PRCA20240398

Project Title:
COASTAL PACIFIC FOOD DISTRIBUTION PUYALLUP

Issue Set & Date:
ISSUE FOR PERMIT (REVISION A)
05/15/2024

Sheet Title:
COVER SHEET

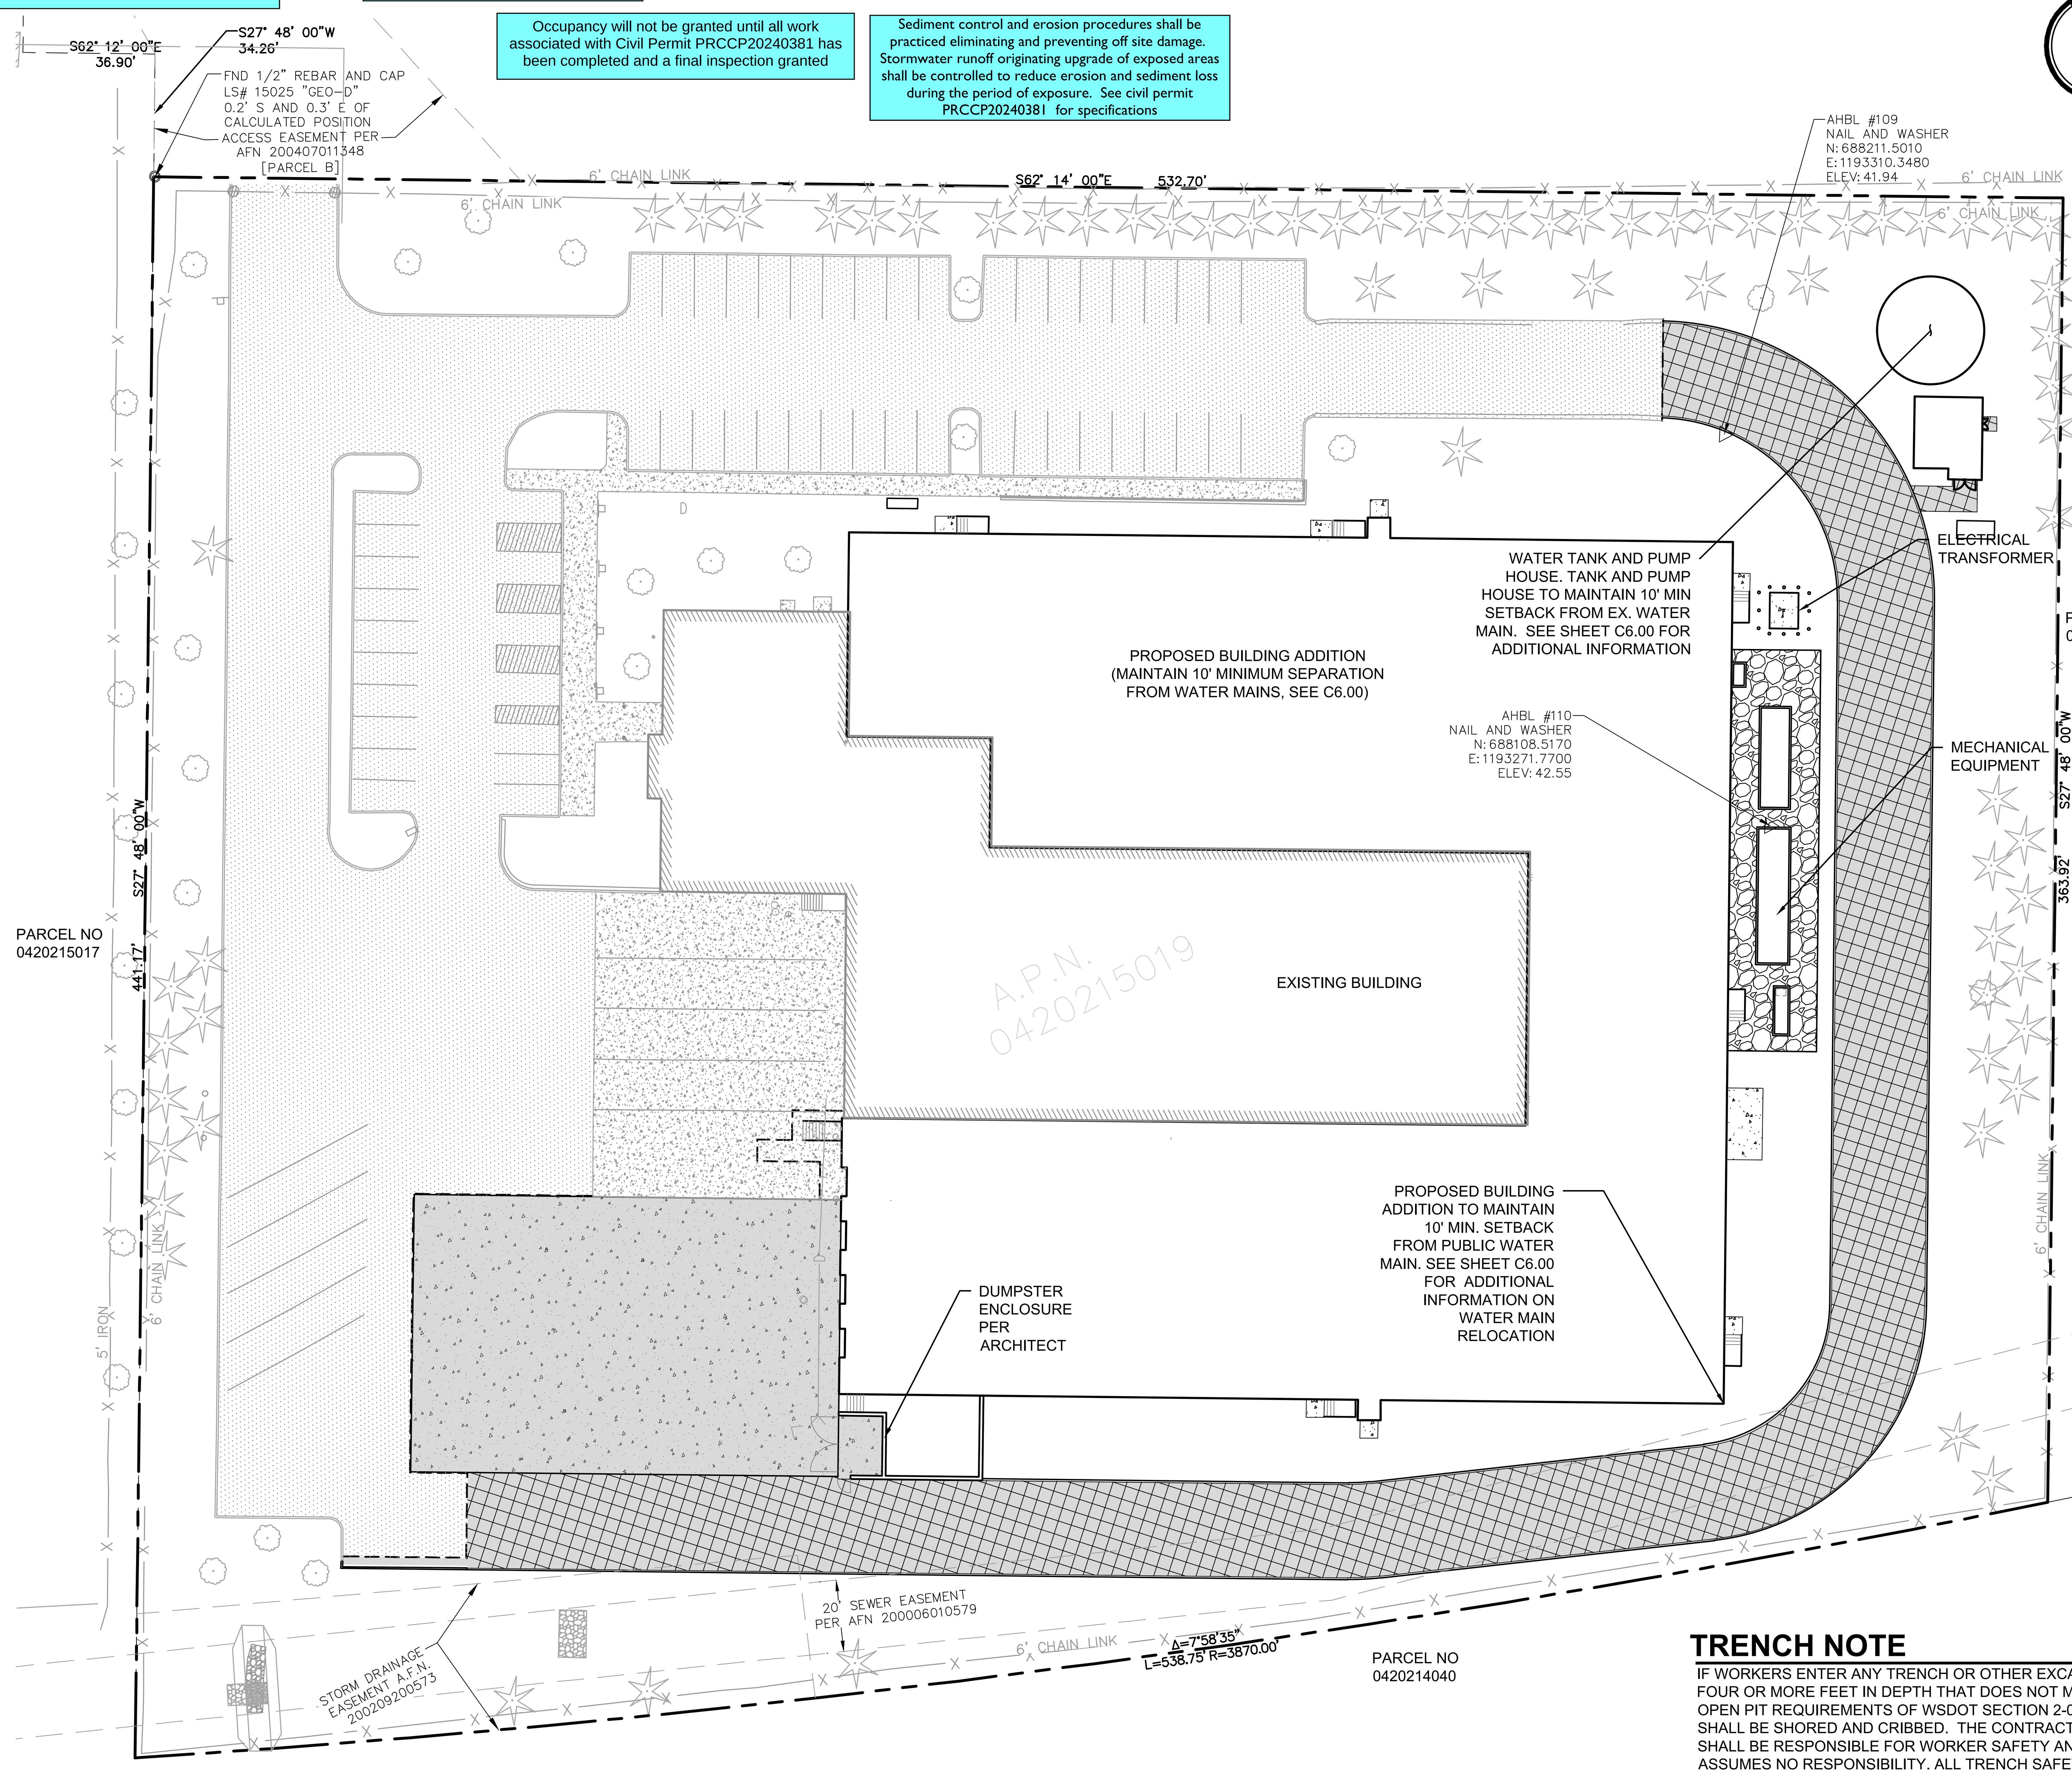
TRASH ENCLOSURE REQUIRES A SEPARTE BUILDING PERMIT

* Trash enclosure will adhere to City Standard 208 Pollution Prevention

** The floor of the trash enclosure shall slope towards the point of sanitary sewer floor drain. The interior Type 1 Catch Basin drains to the onsite sewer system See civil permit PRCCP20231136

*** A grade break shall be provided around the trash enclosure to prevent runoff from entering the enclosure

Roof downspout control is required. Steps shall be taken to prevent drainage onto adjacent lots. See civil permit PRCCP20240381 for specifications

In accordance to Puyallup Municipal Code 14.02.220(3) this project is required to install a double detector check valve assembly (DDCVA). Building occupancy will not be granted until the installation is completed and a final approval granted.

Occupancy will not be granted until all work associated with Civil Permit PRCCP20240381 has been completed and a final inspection granted

Sediment control and erosion procedures shall be practiced eliminating and preventing off site damage. Stormwater runoff originating upgrade of exposed areas shall be controlled to reduce erosion and sediment loss during the period of exposure. See civil permit PRCCP20240381 for specifications

Staff: NComstock
Date: 05/23/2024
Front, rear, and side yard property lines shall be marked with string from surveying pins prior to footing inspection.
